Office Action Summary

10/766,934

OCHIAI, YOSHIHIRO

DETAILED ACTION

Fig. 2

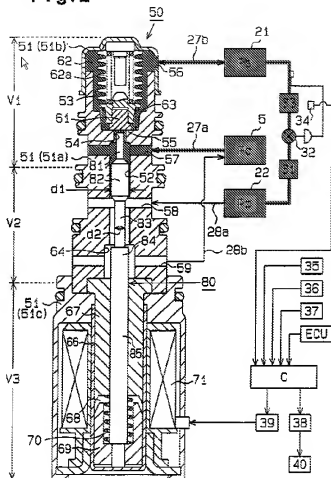
Ota discloses a control valve system for a variable displacement swash plate compressor (see fig. 1) including a valve portion V1 (see embodiment of fig. 7) that is interpreted as a throttling valve and a second valve portion V2 that is interpreted as a constant differential pressure valve. When solenoid coils 71 are energized, rod 80

protrudes into valve seat 61, opening the throttling valve to a certain degree based on external information detecting means (see, for example, col. 6, ll. 35-43), allowing crank chamber 5 fluid into the suction chamber 21. When the pressure difference between the suction chamber (which supplies the fluid to the upstream side portion of valve V1) and crank chamber (downstream side portion) is reduced, bellows 62 expand and push down the rod 80 to open valve portion V2, introducing fluid from discharge chamber 22 into the crank chamber. Solenoid valve V3 constitutes the control means for determining the opening degree of the throttling valve. In regard to the limitation that the upstream portion and the downstream portion of the throttling valve are positioned between the crank chamber and a discharge chamber, because the fluid lines of the variable displacement compressor and its control valve system are continuous, this holds in a fluidic sense. See a recreation of figure 2 below for clarification:

The highlighted portion of the fluid line begins with the discharge chamber 5 and ends with the crank chamber 22, and includes both the upstream and downstream sides of valve V1 in between.
